<b>Item affected / Type</b>	<b>Battery Holder NL5077-LF</b>		
<b>Part - Nr. (SAP)</b>	<b>701112</b>	<b>Drawing-Nr.</b>	<b>3.8756.4-1</b>

<b>Product Change Notification</b>	<b>Reason for proposed change</b>	<b>Description of change</b>
	<input type="checkbox"/> Customer requirement <input type="checkbox"/> Quality complaint Nr. .... <input type="checkbox"/> Quality improvement <input type="checkbox"/> Process improvement – <input type="checkbox"/> technical modification <input type="checkbox"/> Normative requirements <input type="checkbox"/> Cost efficiency <input type="checkbox"/> Second source <input checked="" type="checkbox"/> Correction of the documents <input type="checkbox"/> Production location, change <input type="checkbox"/> see attachment	Correction of tolerances and dimensions on drawing

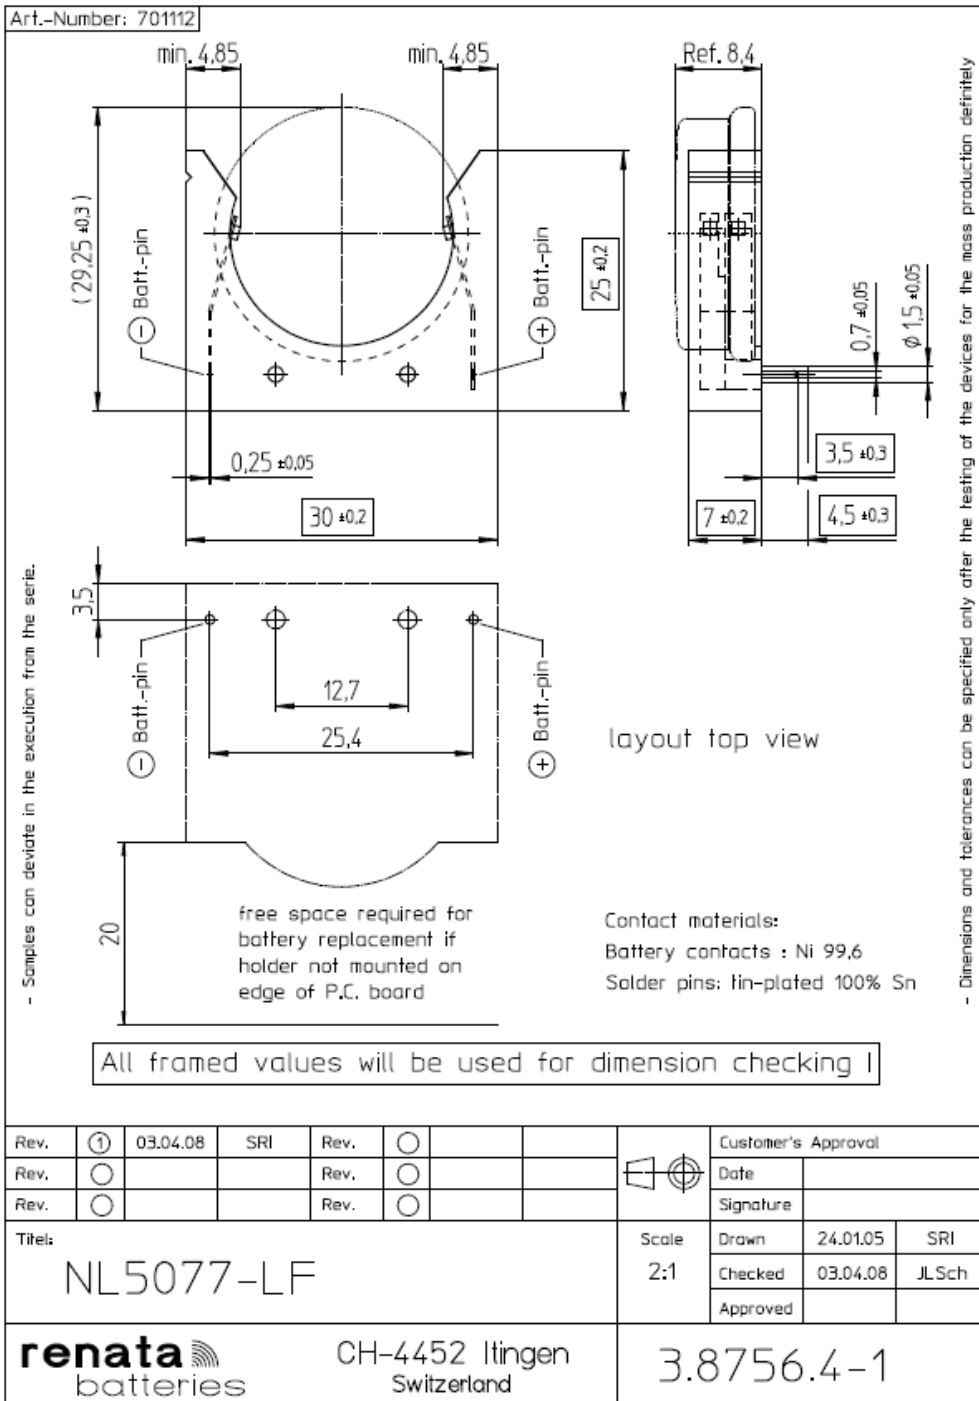
<b>Product Change Notification</b>	<b>Description and reason of change</b>
	<p>Adjustment of tolerances and pin dimension to current product. Renata always produced and released battery holder per new adjusted drawing.</p> <p>Concerned dimensions and tolerances are as below: Marked dimensions &amp; tolerances are adjusted</p> <div style="display: flex; justify-content: space-around; align-items: flex-end;"> <div style="text-align: center;"> <p>actual drawing 3.8756.4-1</p> </div> <div style="text-align: center;"> <p>adjusted drawing 3.8755.4-2 according real production</p> </div> </div> <p>See Annex I and Annex II on following pages for full drawings.</p>
